Calibration of ER for TP3 stress tests

Comment #358

802.3aq

Austin Tx, May 2005

Arithmetic

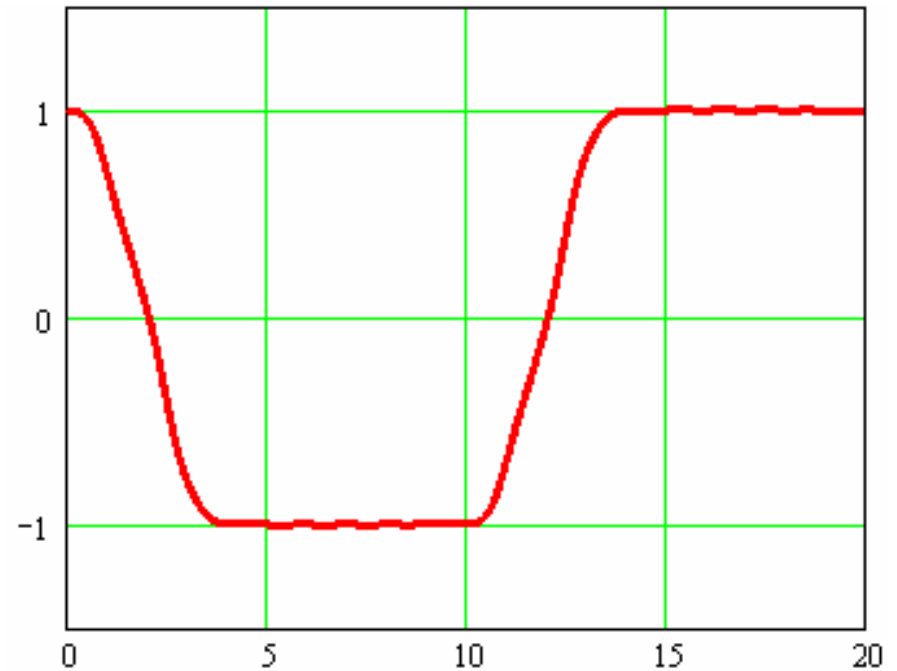
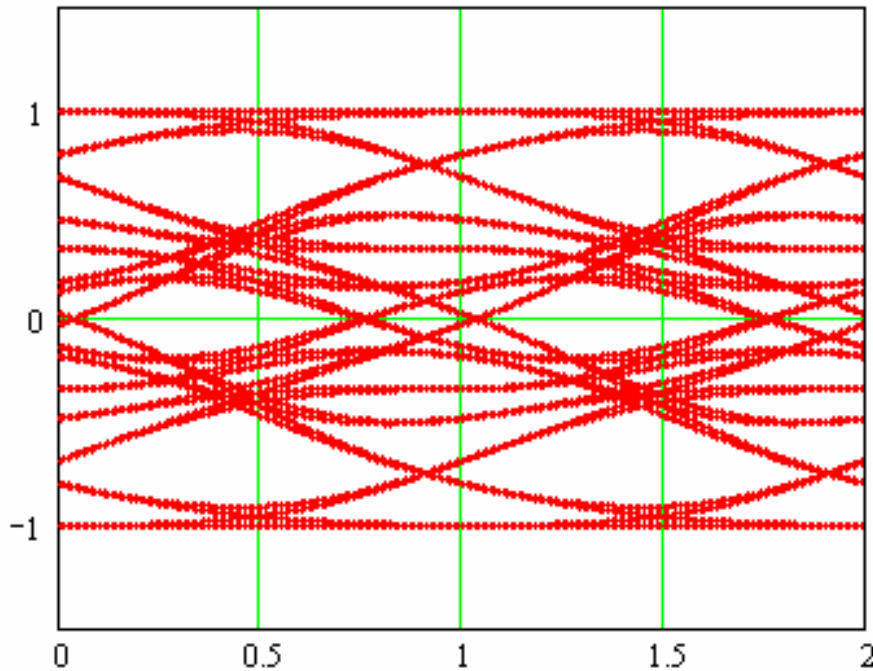
- Simulate basic prbs TP3 source
 - Gaussian and BT4 response
 - No ISI generators
- Determine x , where $x := \frac{\Delta P}{OMA}$
 - x relates ER values to OMA
 - ΔP is difference of ER histogram means
- Topline = 1 & logic1 histogram mean = 0.843
 - So, $x = 0.843$

As above, $x := \frac{\Delta P}{\text{OMA}}$, where $\Delta P := \text{mean}(\text{logic1}) - \text{mean}(\text{logic0})$

- ER for TP3 tester can be calibrated with OMA of square wave cal pattern
 - No need to remove ISI generators
- Set $ER_{OMA} = 4.3$ dB with square wave
 - Use OMA values (not eye histograms)
- For standard
 - Add text in stress test calibration clause
 - Do *not* change Table 68-3
 - *Should* be added to informative test...
